Access Compliance Report

Public Rights-of-Way

Intersection ID: 50613	Main Street: BALSAM_BAY_RD	Cross Street: DOWNY_BIRCH_RD	Location: SW
ADA ID: 79D7DEE7A5F6	Ramp Type: Perp	Initial Pass/Fail: Fail	Overall Compliance: No
		Severity Score: 8.75

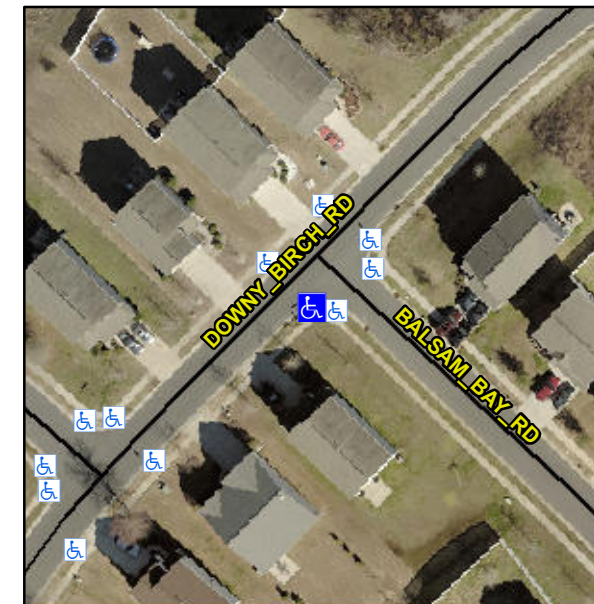
Not Found, R304.5.1

Compliance	Description	Data	Compliance	Description	Data
N/A	Ramp Length (in)	49.0	Yes	Ramp Slope (%)	6.2
No	Ramp Width (in)	38.5	Yes	Ramp XSlope (%)	0.7
N/A	Flare Type LT	N/A	N/A	Flare Type RT	N/A
N/A	Flare Slope LT (%)	N/A	N/A	Flare Slope RT (%)	N/A
N/A	Flare Traversable LT?	N/A	N/A	Flare Traversable RT?	N/A
N/A	Landing Length (in)	N/A	N/A	DWS Provided?	N/A
N/A	Landing Width (in)	N/A	N/A	DWS Contrast?	N/A
N/A	Landing Slope (%)	N/A	N/A	DWS Length (in)	N/A
N/A	Landing X Slope (%)	N/A	N/A	DWS Full Width?	N/A
N/A	Landing Curb? (Y/N)	N/A	N/A	DWS Offset (in)	N/A
N/A	Shared Landing?	N/A			
N/A	Gutter Ponding?	N/A	N/A	Gutter Slope (%)	N/A
N/A	Gutter Lip Ht (in)	N/A	N/A	Gutter X Slope (%)	N/A
N/A	Painted X Walk1?	No	N/A	Painted X Walk2?	N/A
	X Walk 1 Direction	To N		X Walk 2 Direction	N/A
N/A	X Walk 1 Width (in)	N/A	N/A	X Walk 2 Width (in)	N/A
	X Walk 1 Slope (%)	0.6		X Walk 2 Slope (%)	N/A
	X Walk 1 X Slope (%)	2.3		X Walk 2 X Slope (%)	N/A

Remove & Replace Entire Ramp.
